RFQ NUMBER
COR61550

ATTACHMENT A**COR61550****Pruntytown Correctional Center****Road Replacement Project****Questions:**

WV DCC PROJECT # COR6155C
 FACILITY SITE DRAWING
 EXHIBIT #1 - REVISION #1

PRUNTYTOWN CORRECTIONAL CENTER
 ROAD REPLACEMENT PROJECT
 PRUNTYTOWN, WEST VIRGINIA

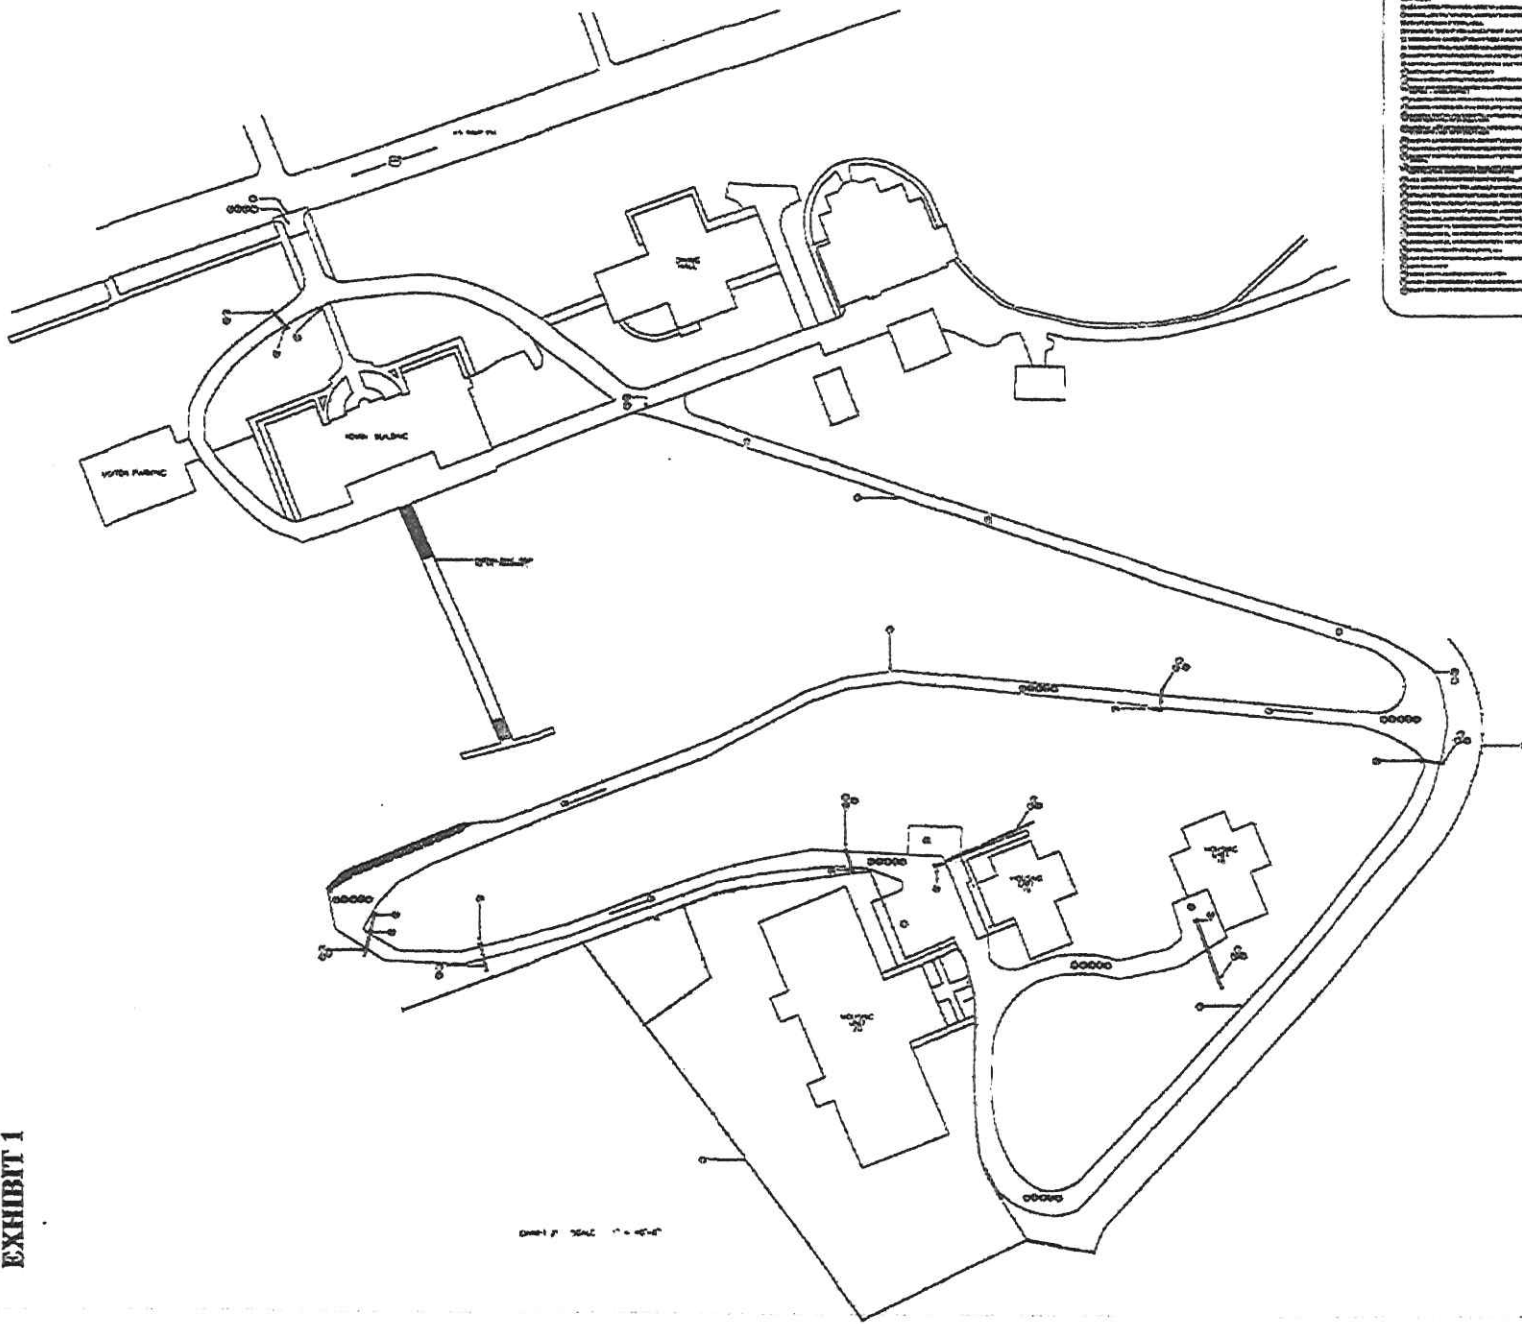
- A2: Accepted to use latex paint.
- Q3: We recommend a drop inlet in front of building #19.
- A3: Please see information in the below clarification and attached drawing.

- C1: At the entrance to Administration I Building, the concrete has been extended an additional three feet (3') onto the side of the road. Please see attached drawing to see the changes. It will be the contractor responsibility to coordinate with the Taylor County Department of Highways concerning this area.

- C3: Please see Exhibit #1 – Revision #1 for new drawing layout.
- C4: Please see Exhibit #2 for Key Notes that are on Exhibit #1 – Revision #1.
- C5: Please replace the Bid Form with the following revised bid form.

Exhibit #2 – See Map Exhibit 1

4. CONCRETE TO BE 9" THICK FOR 12' WIDE X 21' LONG AREA. THE AREA THAT EXTENDS ONTO THE ROAD IS WIDER THAN 12" AND CURVES AROUND THE SIDEWALK.
5. PROVIDE ONE LAYER OF HEAVY WIRE MESH WVDOT STANDARD.

6. WIRE MESH TO BE PLACED IN THE CENTER FOUR AND A HALF INCHES (4.5") ABOVE THE BOTTOM OF THE BOTTOM OF THE CONCRETE BOTTOM.
7. WIRE MESH TO EXTEND WITHIN SIX INCHES OF THE SIDES OF THE CONCRETE AREA.

8. ADD ONE (1) SIXTEEN INCH (16") METAL CULVERT PIPE TWENTY FEET (20') IN LENGTH AND CONCRETE INLET BOX.
9. BOTTOM POINT OF PAVING PROJECT.
10. THE EXISTING ASPHALT ROAD IS AN ESTIMATED TWELVE FEET (12') WIDE.

13. REMOVE EXISTING FIFTEEN INCH (15") CULVERT PIPE THAT EXTENDS FORTY-TWO FEET (42') IN LENGTH. INSTALL NEW SIXTEEN (16") METAL CULVERT PIPE WITH NEW CONCRETE INLET BOX.
